Notice of Intent

Type of Action: APD Change

Procedure Description: Devon Energy Production Co., L.P. (Devon) respectfully requests a change to the drilling plan for the Morgan 25-13 Fed Com 627H and 737H to include break test variance with stump testing . Attachment included.

PECOS DISTRICT DRILLING CONDITIONS OF APPROVAL

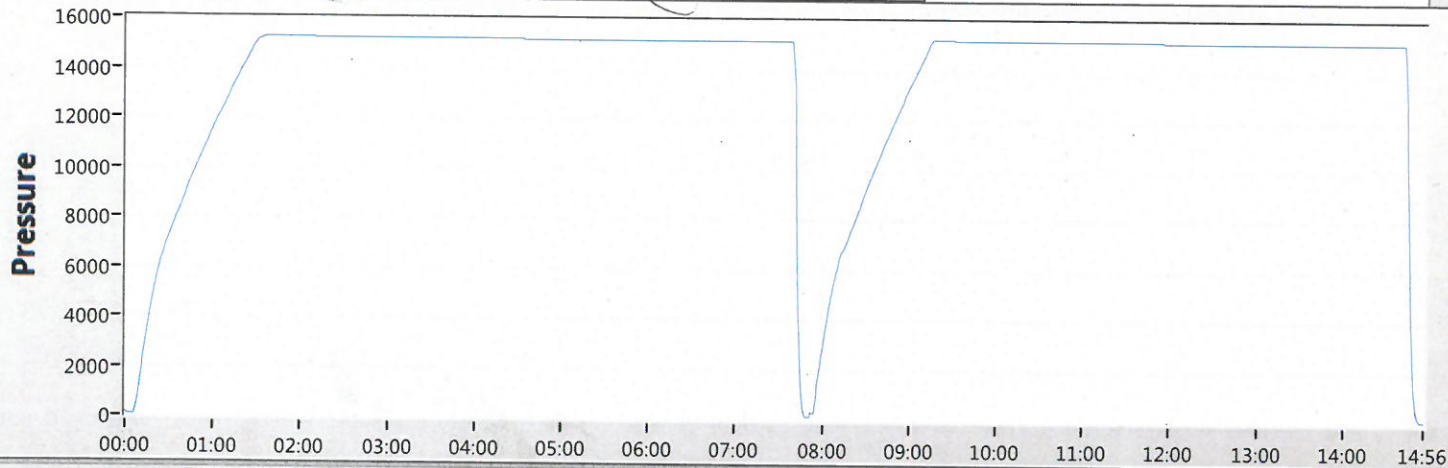
Devon Energy requests to only test BOP connection breaks after drilling out of surface casing and while skidding between wells which conforms to API Standard 53 and industry standards. The initial BOP test will follow 43 CFR 3172, and subsequent tests following a skid will only test connections that are broken. This test will at minimum include the Top Pipe Ram, HCR, Kill Line Check Valve, QDC (quick disconnect to wellhead) and BOP shell of the 10M BOPE to 5M for 10 minutes. Additional pressure testing is required for pressure-containing and pressure-controlling connections when the integrity of a pressure seal is broken. If a break to the flex hose that runs to the choke manifold is required due to repositioning from a skid, the HCR will remain open during the shell test to include that additional break. The variance only pertains to intermediate hole-sections. This variance will meet or exceed 43 CFR 3172 per the following: Devon Energy will perform a full BOP test per 43 CFR 3172 before drilling out of the intermediate casing string(s) and starting the production hole, testing the Annular during initial BOP testing to a minimum of 70% RWP and higher than MASP, and pressure testing at a 21-day interval frequency. The BLM will be contacted 4hrs prior to a BOPE test. The BLM will be notified if and when a well control event is encountered. In the event break testing is not utilized, then a full BOPE test would be conducted.

Devon Energy requests to perform offline BOP stump testing and offline BOPE testing. All pressure-containing and pressure-controlling seals will be tested either online or offline as denoted in the table below and per BLM approval during initial BOP test following test pressure requirements set forth in 43 CFR 3172. Remaining components not tested offline or on the stump will be tested within 72-hours when the BOP is connected to the wellhead. If stump testing exceeds 72-hour window prior to connecting to the wellhead, the BLM will be notified and either stump testing restarted, or the BOP being tested online. The BLM will be contacted 4hrs prior to a BOPE test. The BLM will be notified if and when a well control event is encountered. In the event stump testing is not utilized, then a full BOPE test would be conducted.

Pressure testing is required for pressure-containing connections if the integrity of a pressure seal is broken during a break test

Full Tests required when entering production hole

All Previous COAs Still Apply. Variance request procedure is approved as written, please see below general conditions for variance.

Operator has been **(Approved)** to test the BOPE offline.

The BOPE offline testing shall be stationary during pressure testing.

Online BOPE testing should commence within 72 hours of offline BOPE testing completion. Notify the BLM if interval exceeds 72 hours.
